Amendments to the Drawing

Remarks/Arguments

Applicants have received and carefully reviewed the Office Action of the Examiner mailed January 7, 2008. Currently, claims 1-48 remain pending of which claims 12, 23, 24, and 28-48 are withdrawn from consideration. Claims 1-11, 13-22, and 25-27 have been rejected. Although not noted in the Office Action Summary, claims 2 and 26 have been objected to. Favorable consideration of the following remarks is respectfully requested.

Fig. 1A

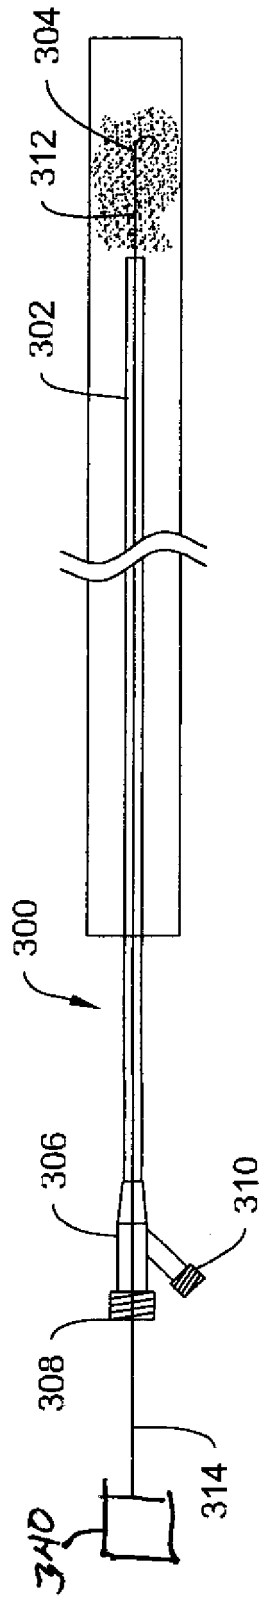
The Examiner has requested illustration of the motion control apparatus of claim 14. Accordingly please accept the replacement sheet. The requested motion control apparatus and associated reference numeral 340 has been added to Figure 1A.
